GN-01: Closure, Wildlife and Vegetation Impacts

Kugluktuk New Power Plant and Solar Proposal (NIRB-19XN011) 5/9/2019

Figure 1: Typical Drum Storage Area

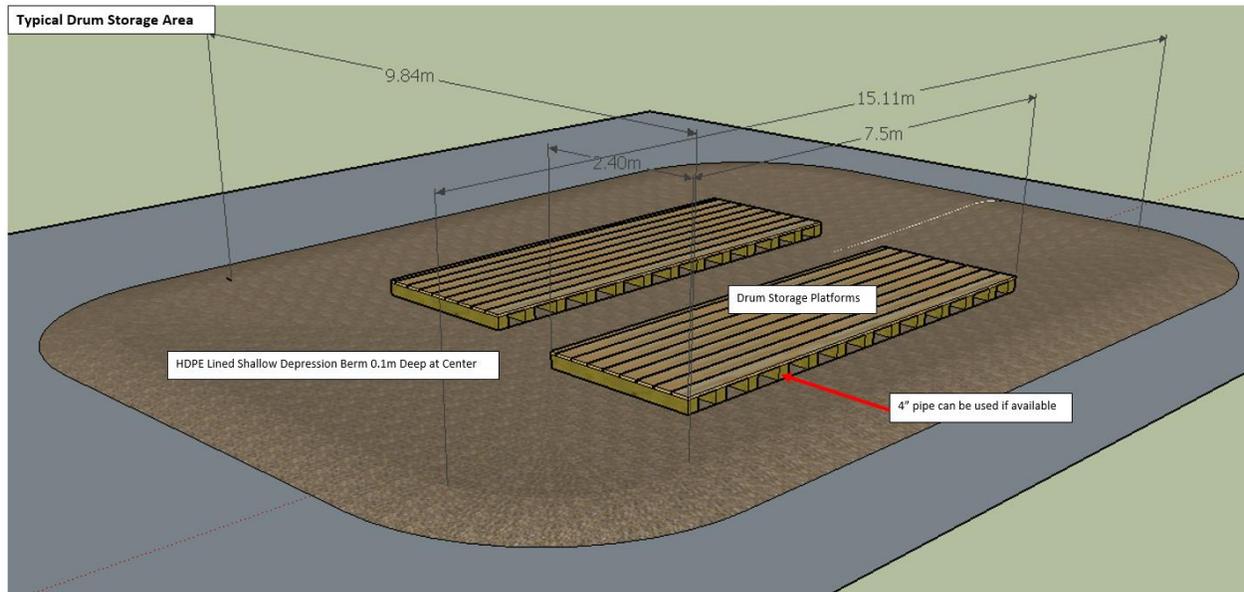
4. Describe expected emissions and confirm compliance with the applicable environmental standards or industry best practices.

- iv. All product storage areas (drums) will be designed in a lined area to guard against hazardous material entering the environment. As well, all product transfer areas are designed with secondary containment. The fuel system will be designed with redundant systems for fuel overfill protection and spill prevention (Figure 1).
